CITY OF ALBUQUERQUE

**RE: Restaurant Depot
1901 Menaul Blvd NE
Grading and Drainage Plan
Engineer's Stamp Date: 06/28/22
Hydrology File: H15D039**

Based upon the information provided in your submittal received 07/11/2022, the Grading & Drainage Plan **is not** approved for Building Permit and Grading Permit. The following comments need to be addressed for approval of the above referenced project:

DRAINAGE PLAN

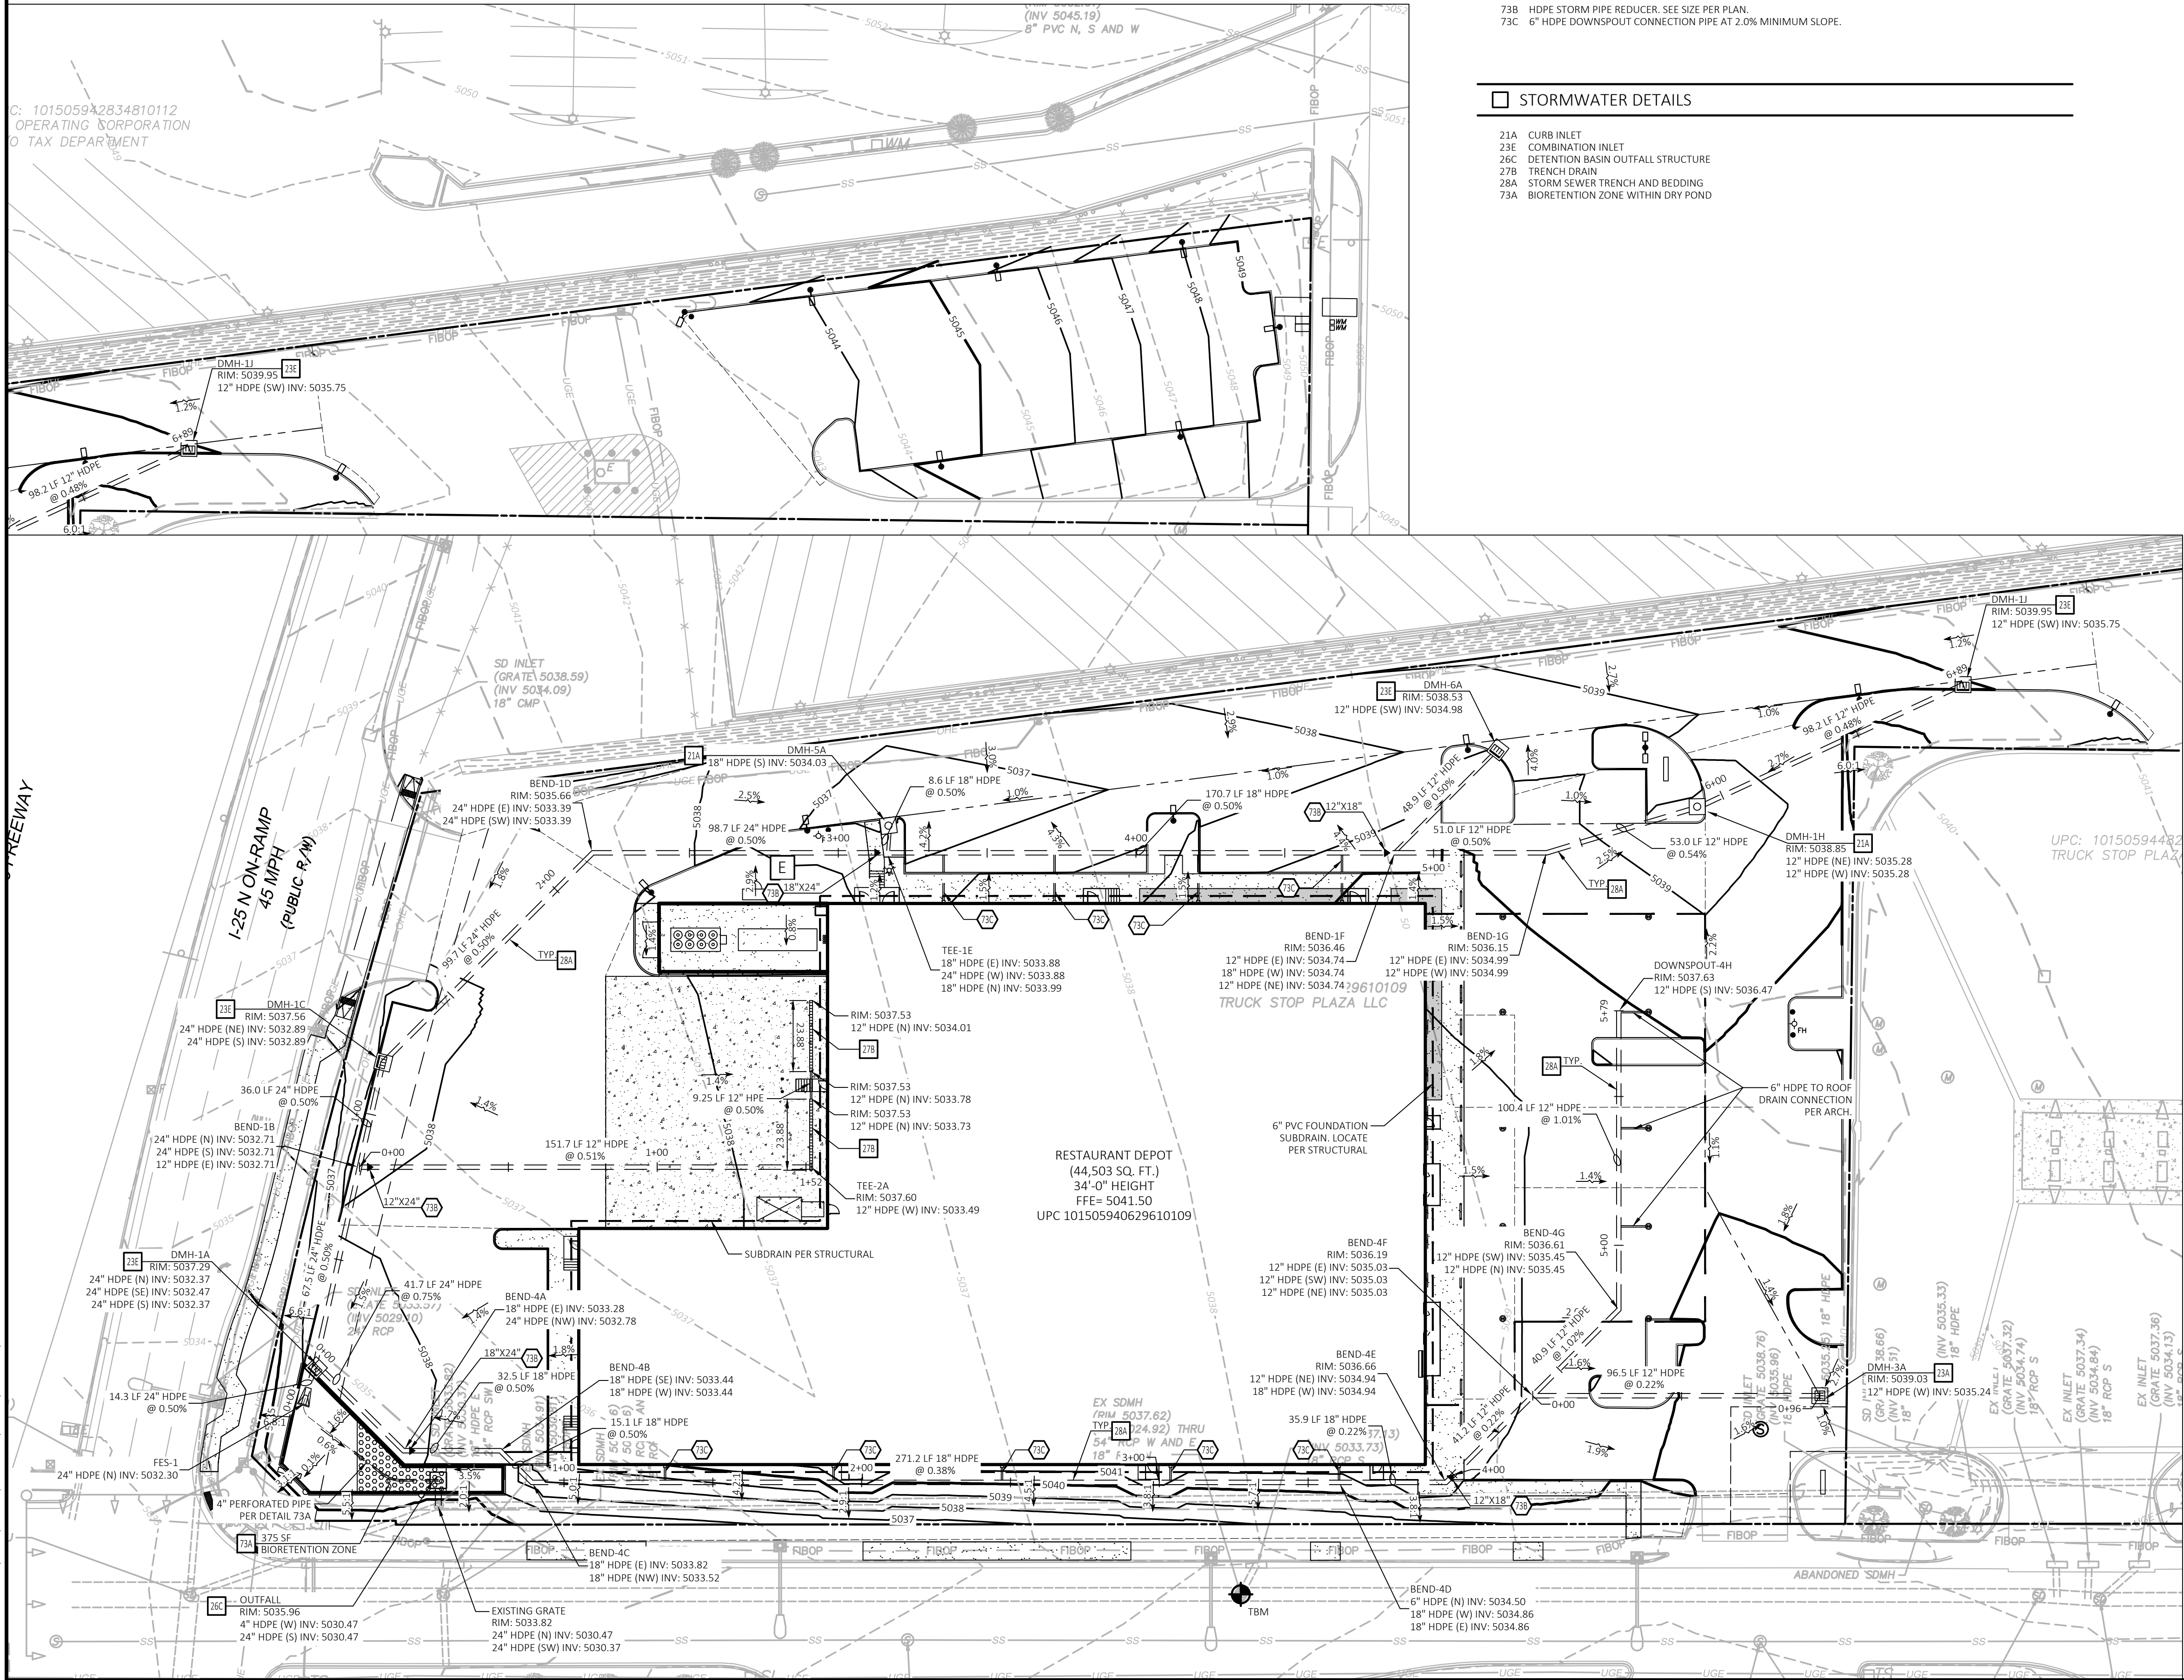
Drainage Plan – C4.1

2. Please use the procedure for 40 acre and smaller basins as outlined in Development Process Manual (DPM) Article 6-2(a). Please provide both the existing conditions and proposed conditions for the 100 year-6 hour storm event.
3. Provide management onsite for the Stormwater Quality Volume (SWQV) in accordance with the Drainage Ordinance, § 14-5-2-6 (H) and the DPM Article 6-12 Stormwater Quality and Low-Impact Development for the sizing calculations. To calculate the required SWQV, multiply the impervious area draining to the SWQ pond by 0.42 inches for new development sites and 0.26 inches for redevelopment sites. This development is a

re-development so please use 0.26 in this site's calculations. Please show both the required and the provided volume.

4. The onsite drainage should be directed to the stormwater quality (SWQ) ponds prior to being collected in a private underground drainage system. These SWQ ponds need to be sized for the areas draining to them. Also, please show the top and bottom of the ponds along with the volume for each pond.
